21G-11-0157
GOV-01-55-04
ACF-11-0244
September 9, 2011

Subject: Revisions for Chapter 1, Addendum, Chapter 2, Chapter 5, Chapter 10, and Chapter 11 for Renewal of SNM License 124

Nuclear Fuel Services, Inc. (NFS) hereby submits the following revisions for the renewal of SNM License 124:

Attachments 1 and 2 contain proposed changes to incorporate responses to the Request for Additional Information (References 5 and 6). Changes are denoted with lines in the right hand margin of the pages.

**SPECIAL NUCLEAR MATERIAL LICENSE
SNM-124
CHAPTER 2
Figure 2-1**

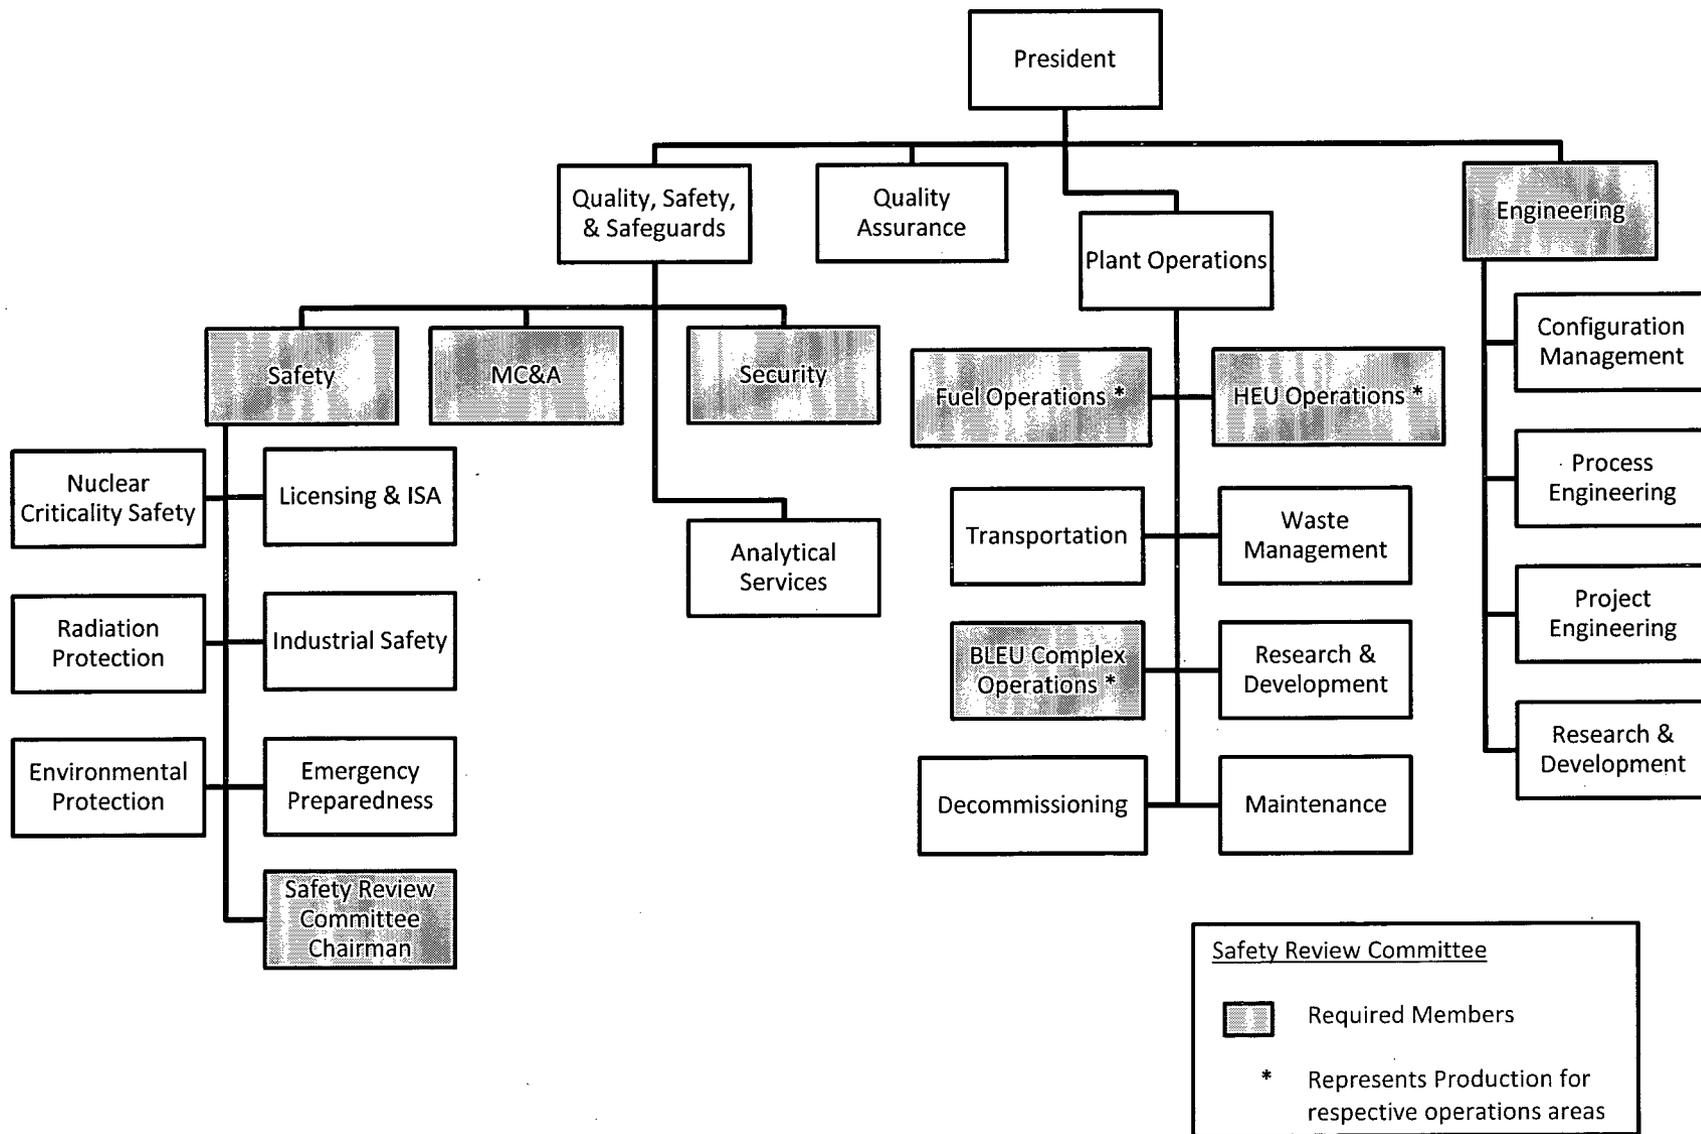
Due to a recent organizational change involving the Quality Assurance discipline, Figure 2-1 has changed. In addition, a minor update was made to the qualifications regarding the manager responsible for the fire protection program. Finally, a formatting error was discovered on Page 2-10. Attachment 3 contains Pages 2-8, 2-10, and 2-12, and is
